Re: Secondary Adequacy Review, TR-136, Cresson Project, M1980-244

On September 26, 2023, Newmont Corporation's Cripple Creek and Victor Gold Mining Company (CC&V) received the Division of Reclamation, Mining and Safety (DRMS) secondary adequacy review of Technical Revision (TR) 136 to Permit M-1980-244, regarding the Numeric Protection Level Recommendations. Below are DRMS comments in **bold** and CC&V's responses in *italics*.

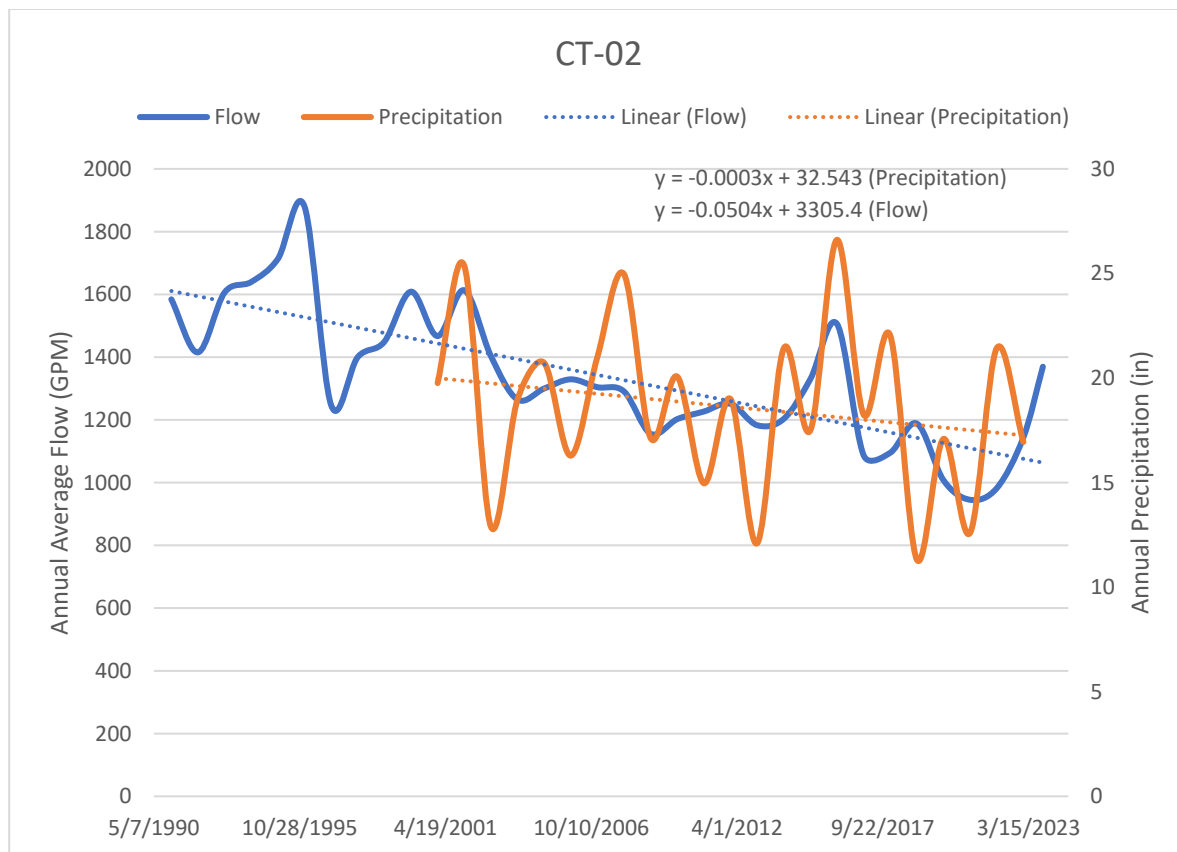
3. **The Applicant quotes Adrian Brown's February 2012 potential impacts and conclusions. Can the predicted impacts to the Carlton Tunnel discharge be verified?**

Adrian Brown concluded: "A temporary possible decrease of approximately 170 acre-feet per year (~100 gpm) in the flow of water from the regional groundwater system via Carlton Tunnel due to the installation of the SGVLF liner system." This conclusion does not account for any potential changes in precipitation rate, which would not be a result of MLE2 activities.

As the graphic below illustrates, the flow from the Carlton Tunnel has decreased by over 200 gpm, due to a combination of decreased precipitation in the basin and the reduction in infiltration due to the installation of the VLF liner system. It is difficult to quantify exactly how much of this decrease is due to the VLF liner installation, but there is a clear decrease in flow in excess of that expected due to decreased precipitation.

*Carlton Tunnel Flow Rate prior to MLE 2: 1,500 gpm
 Carlton Tunnel Flow Rate Observed (2011-Current): 1,200 gpm*
